Addendum No. 03

PROJECT: PRESIDENT WOODROW WILSON HOUSE BUILDING SYSTEMS IMPROVEMENTS

DATE: JULY 27, 2026

RE: ADDENDUM NO. 3 TO REQUEST FOR PROPOSAL 2026-09, ISSUED JULY 6, 2026

E-100

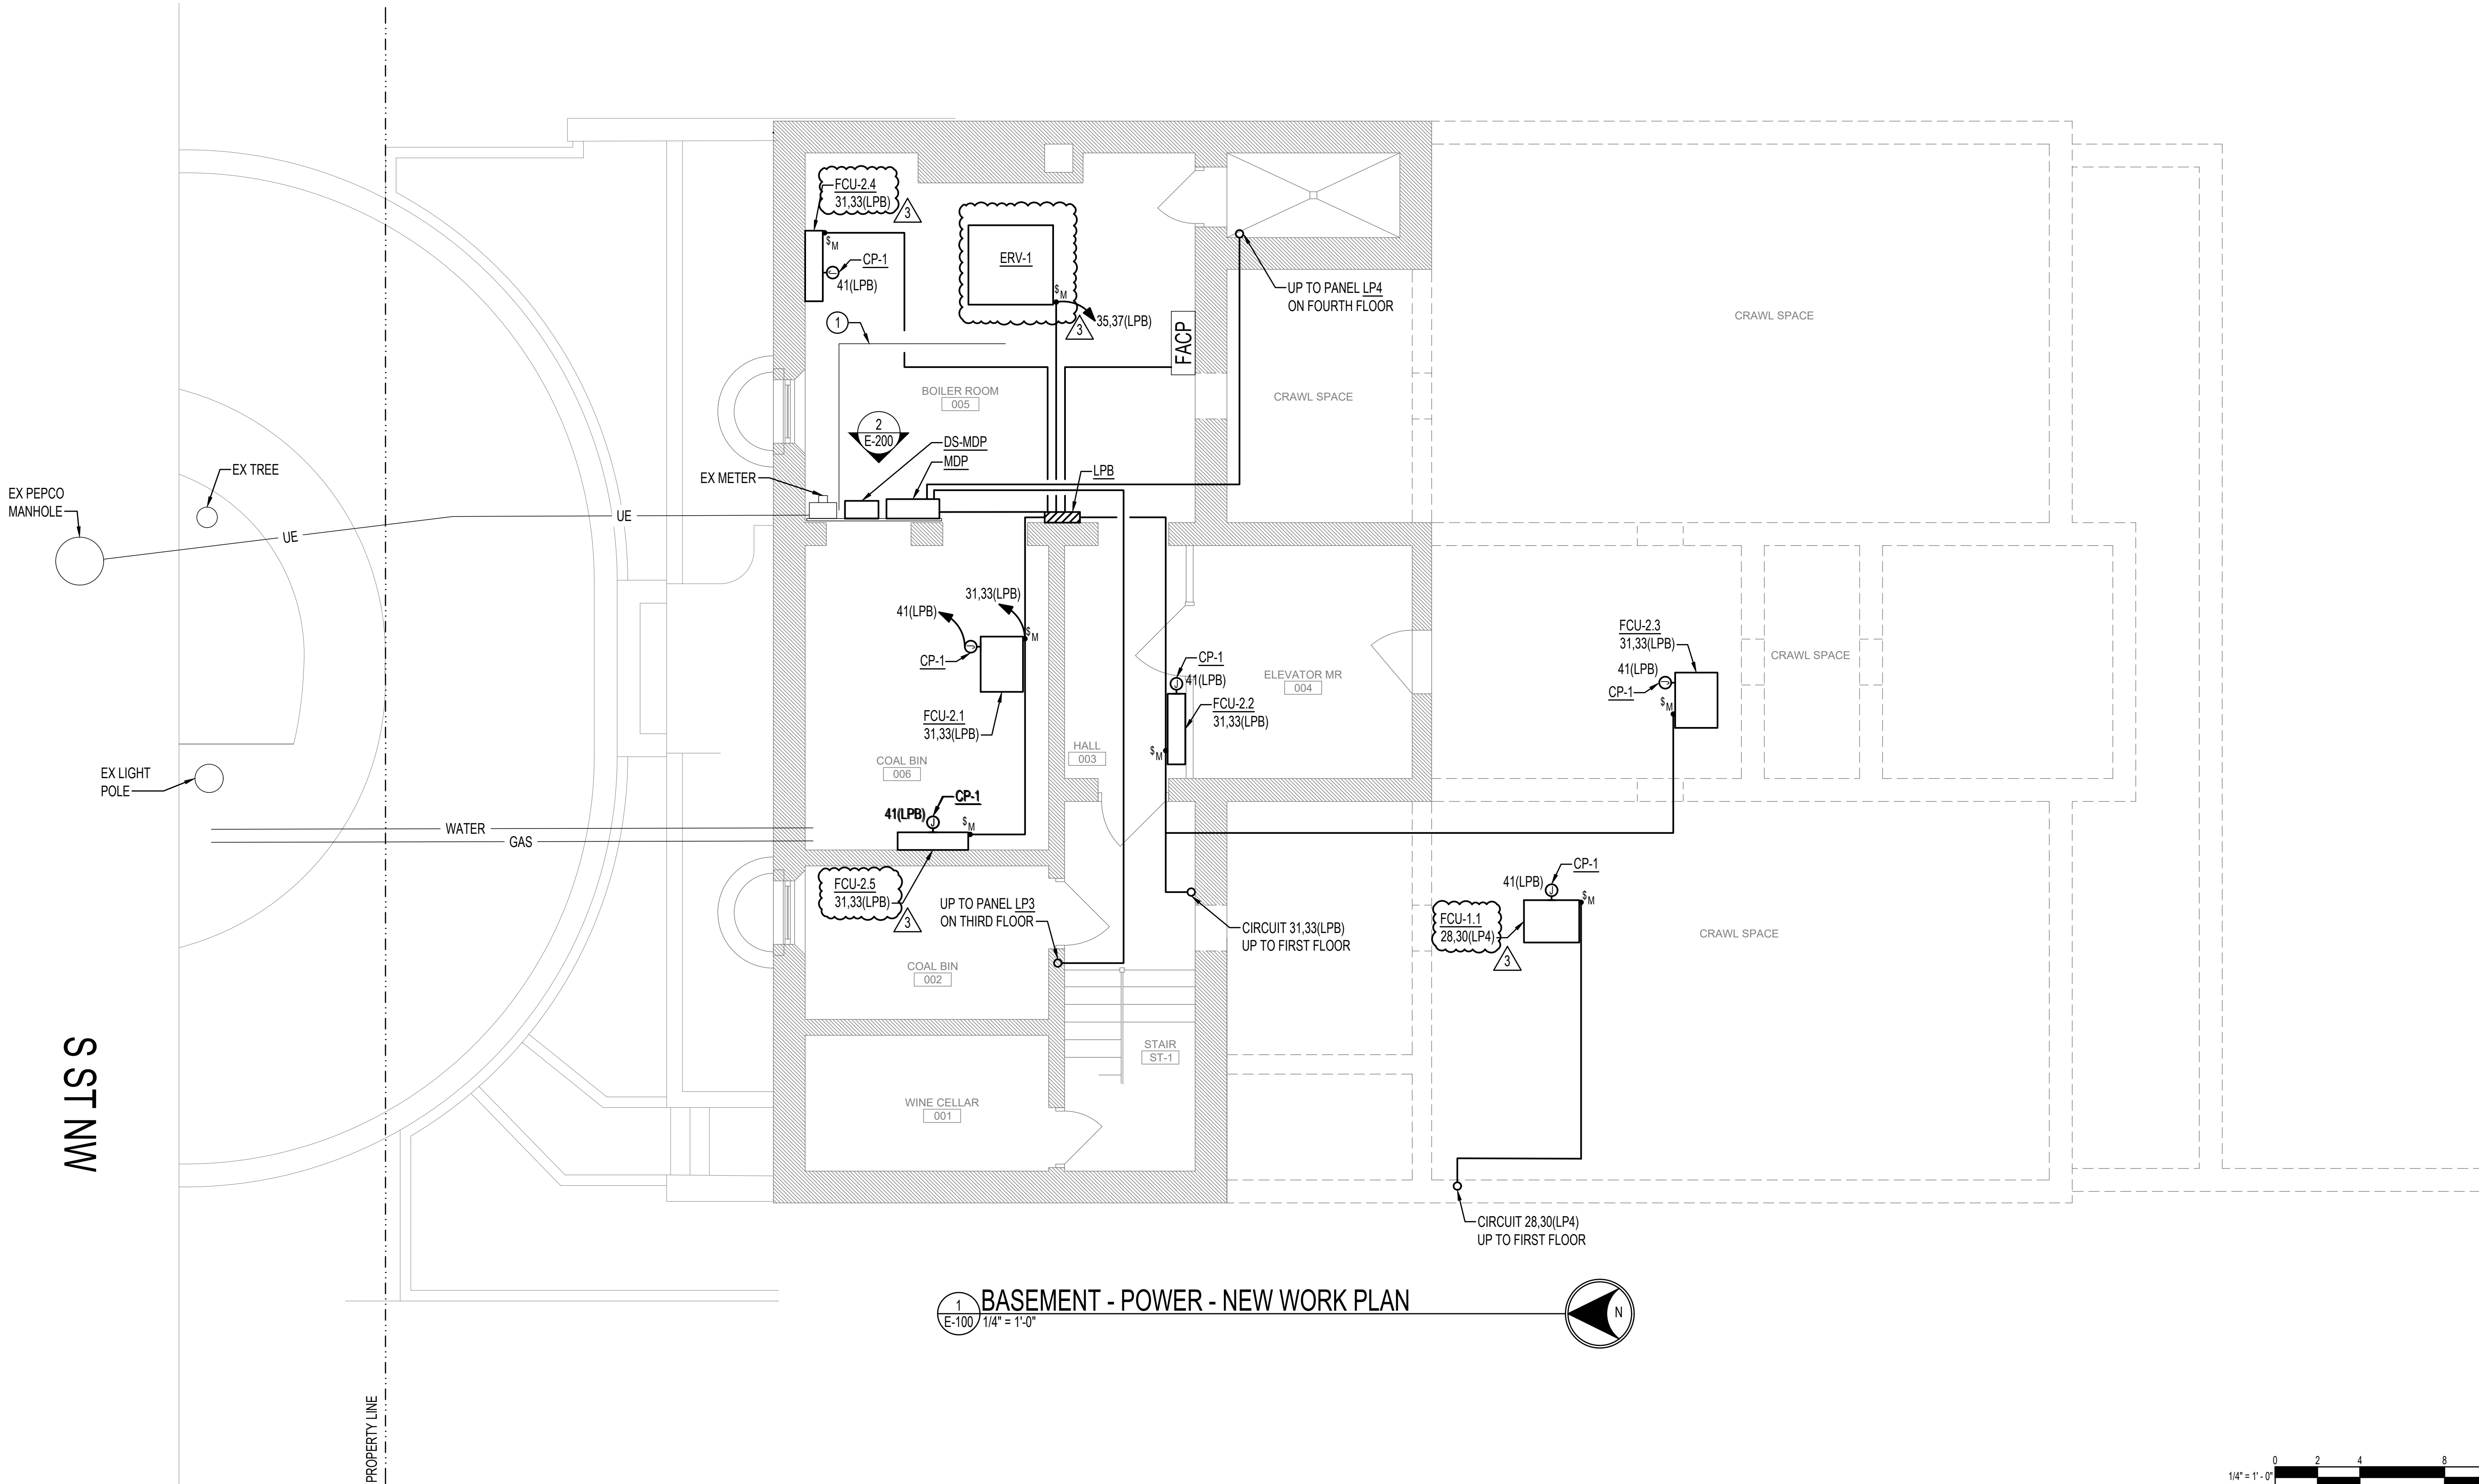
- a. Update VRF Heat Pump Unit electrical data per revised sheet.
 - b. Update VRF Fan Coil Unit designations and electrical data per revised sheet.
9. SHEET E-100 BASEMENT – POWER – NEW WORK

- a. Update FCU designations per revised sheet.
10. SHEET E-101 FIRST FLOOR – POWER – NEW WORK
 - a. Update FCU designations per revised sheet.
11. SHEET E-102 SECOND FLOOR – POWER – NEW WORK

1 SECOND FLOOR - POWER - NEW WORK PLAN
E-102 1/4" = 1'-0"

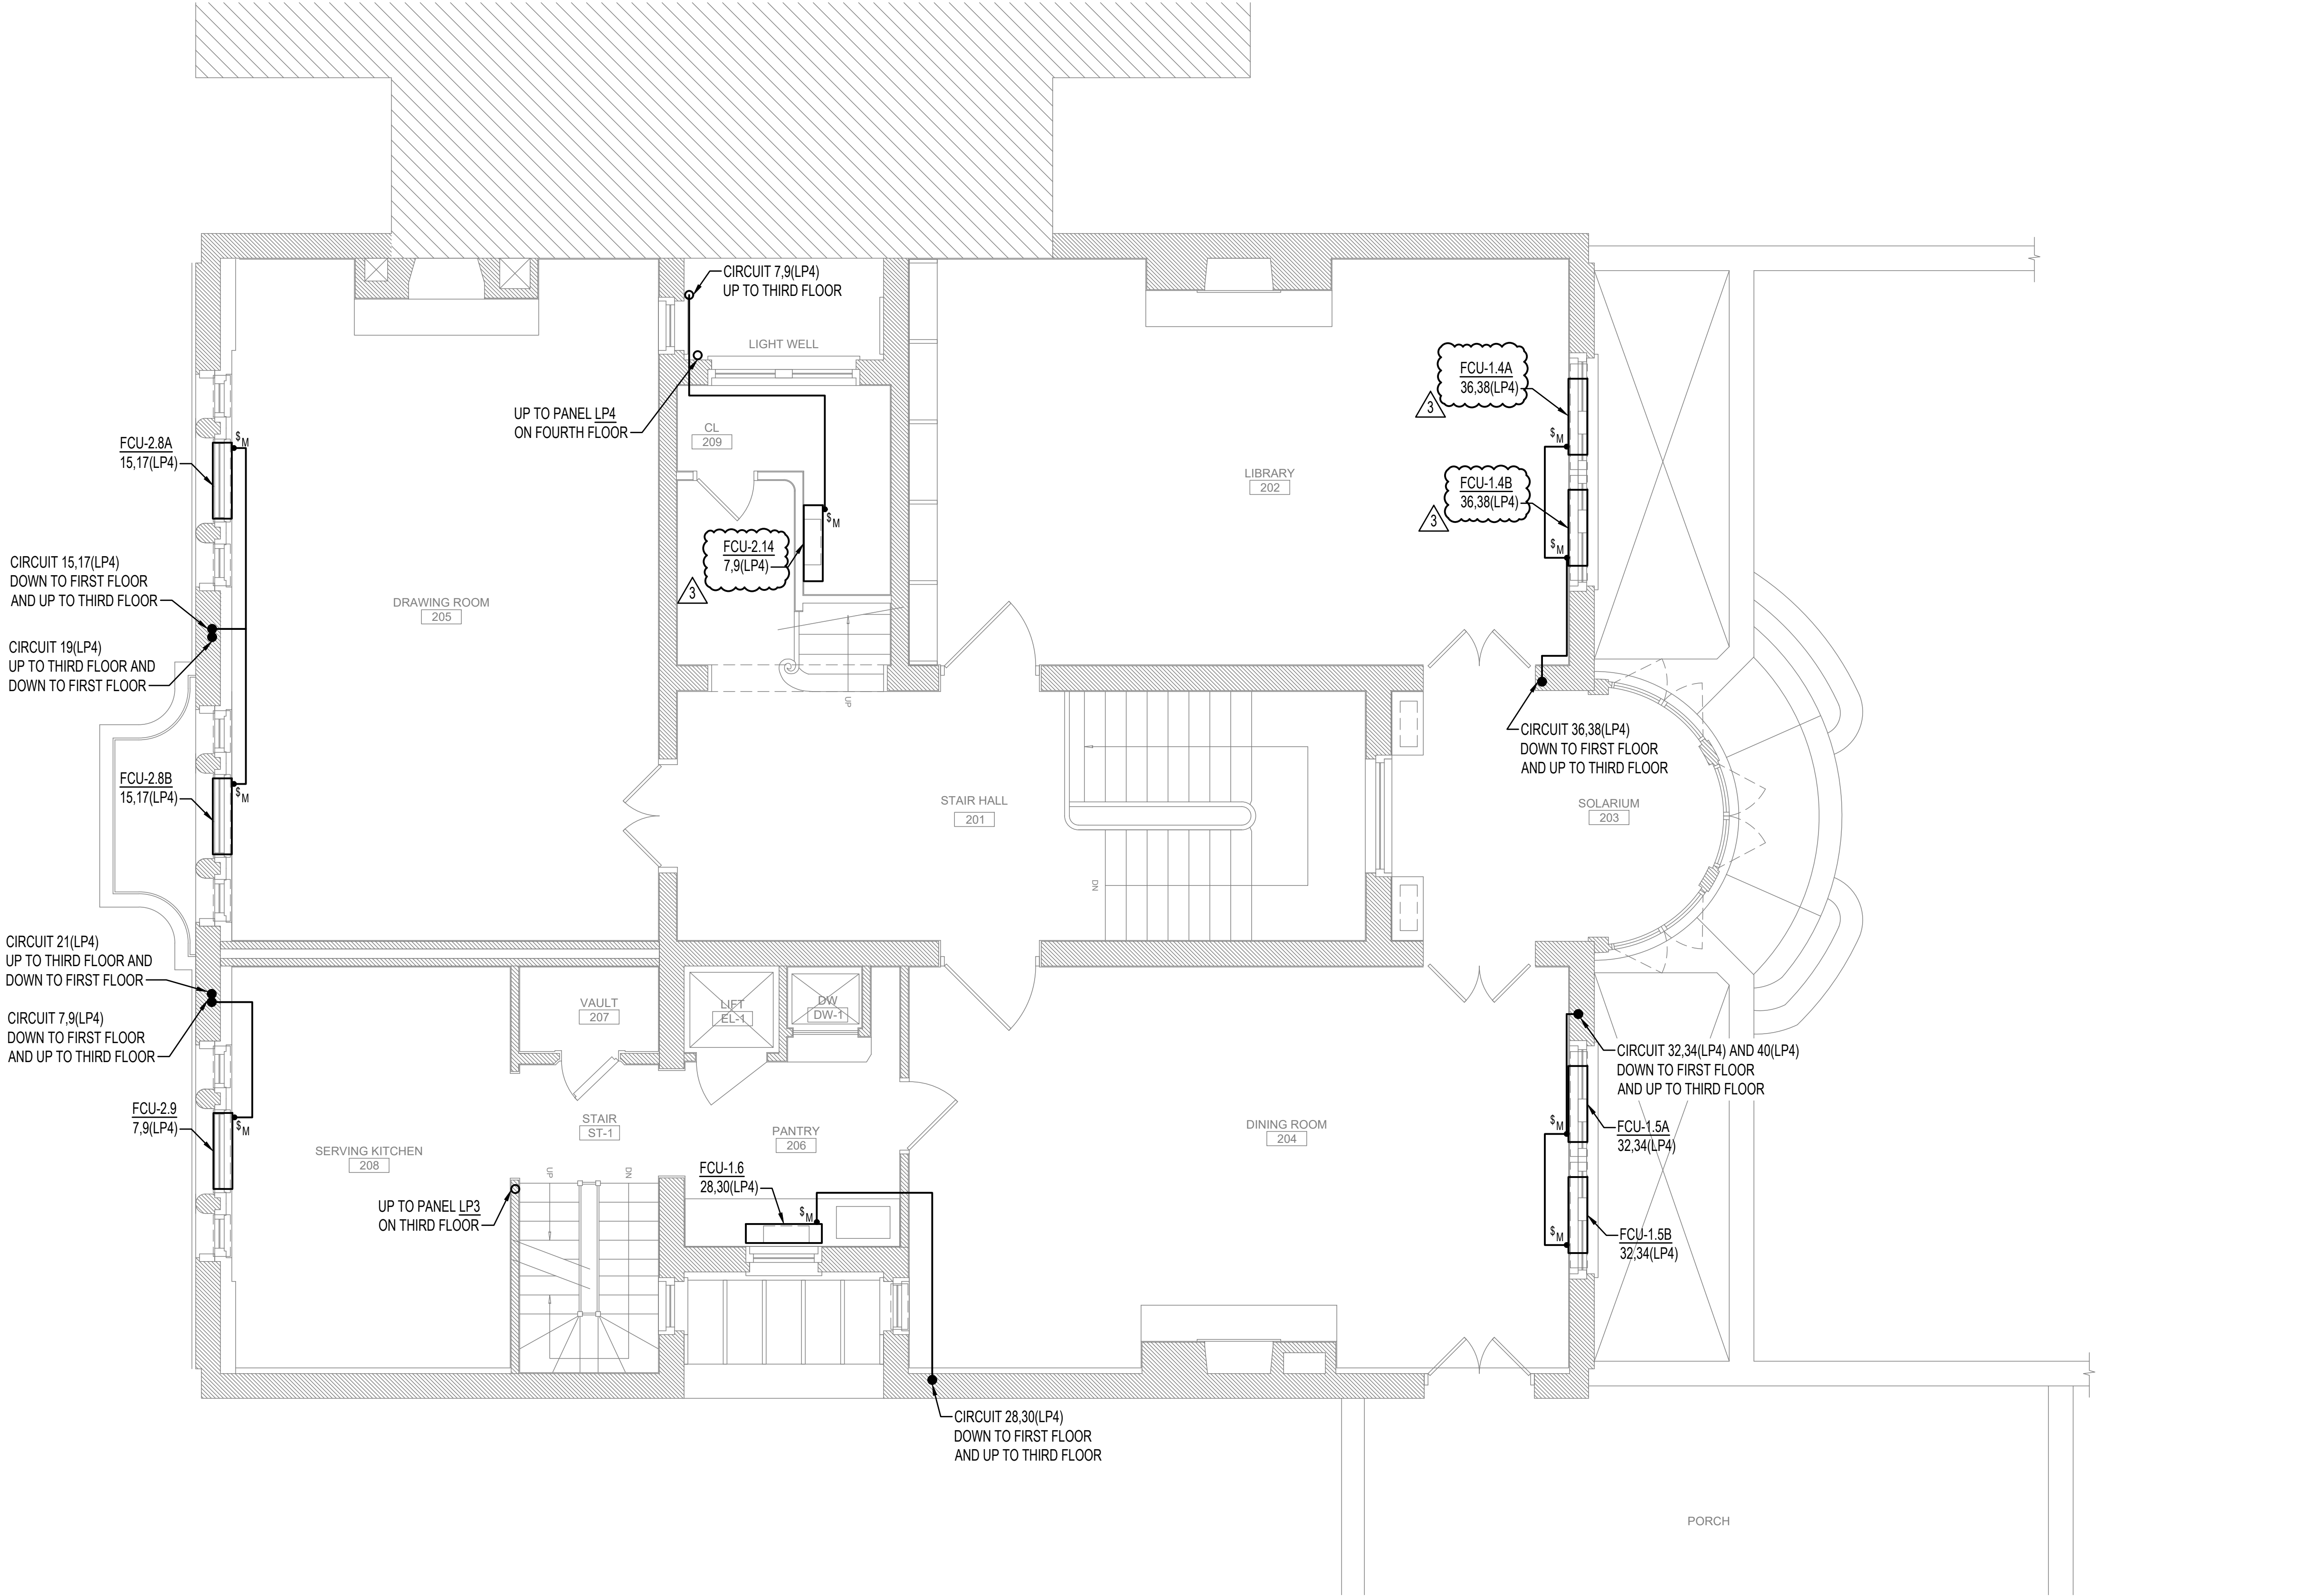
- a. Update FCU designations per revised sheet.
12. SHEET E-103 THIRD FLOOR – POWER – NEW WORK
 - a. Update FCU designations per revised sheet.
13. SHEET E-104 FOURTH FLOOR – POWER – NEW WORK

1
E-104
FOURTH FLOOR - POWER - NEW WORK PLAN
1/4" = 1'-0"

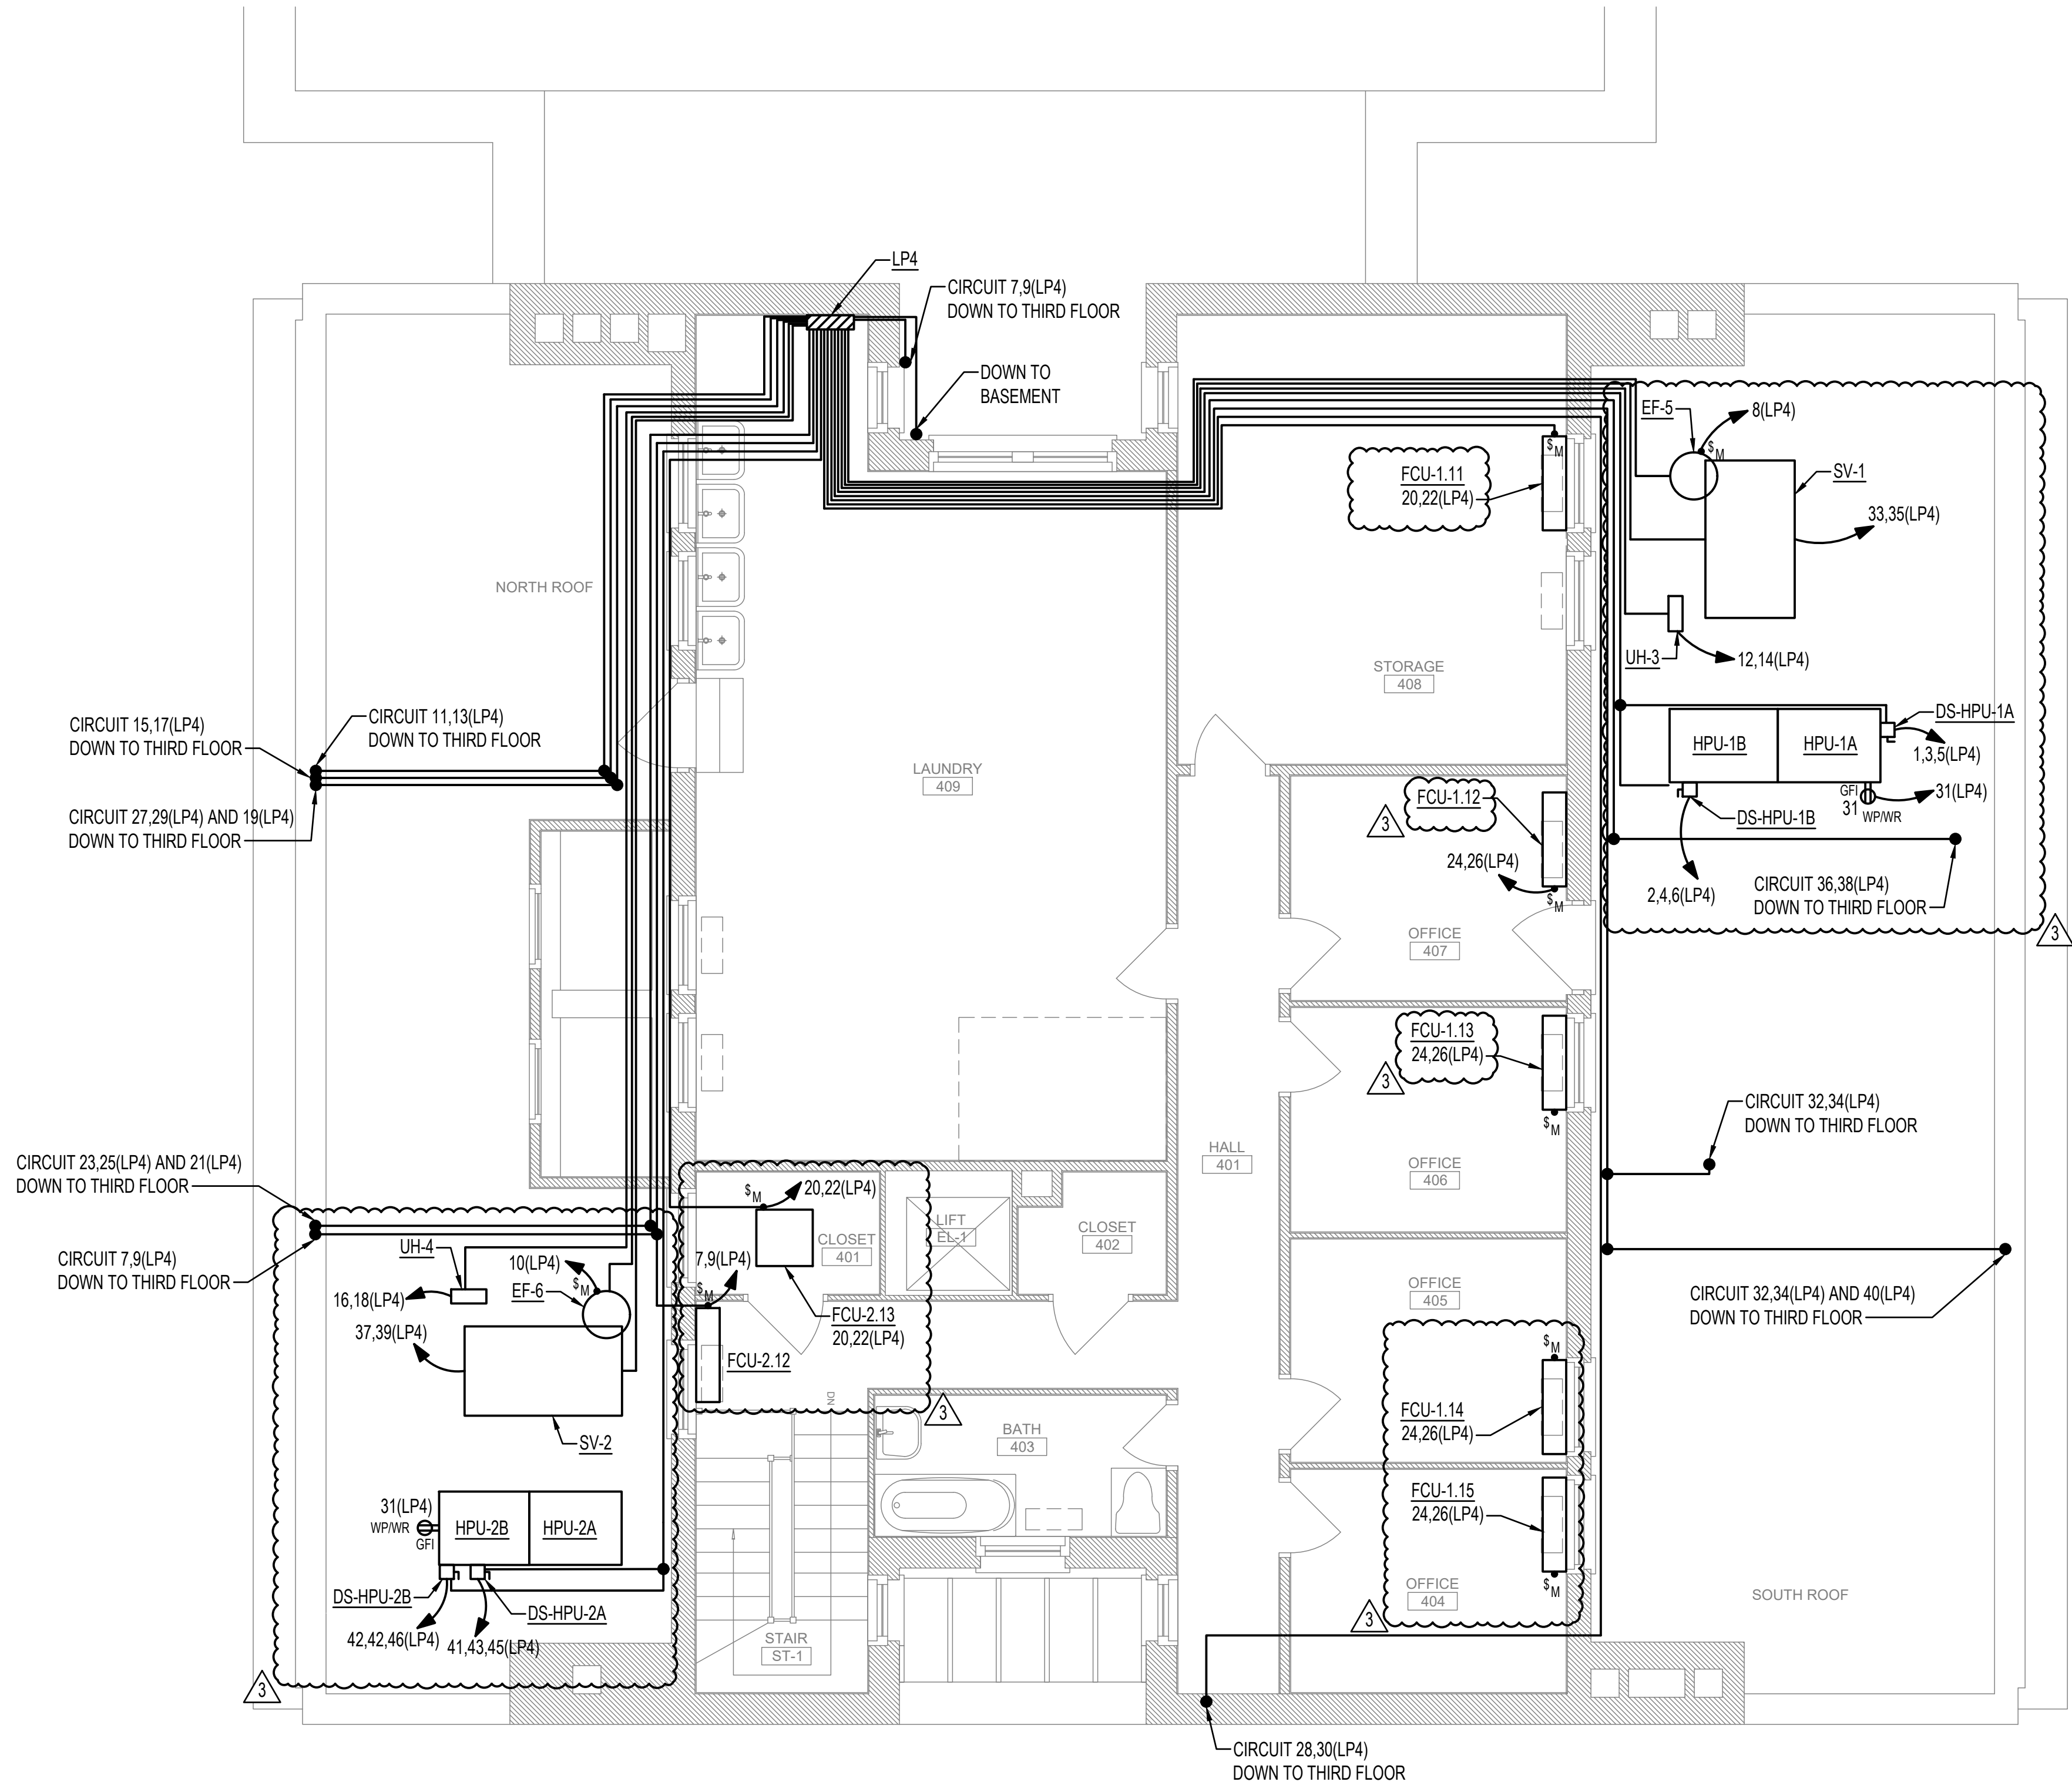
- a. Update FCU designations per revised sheet.
14. SHEET E-602 ELECTRICAL ONE-LINE DIAGRAM – NEW WORK
 - a. Update one-line diagram to reflect HPU disconnect changes per revised sheet.
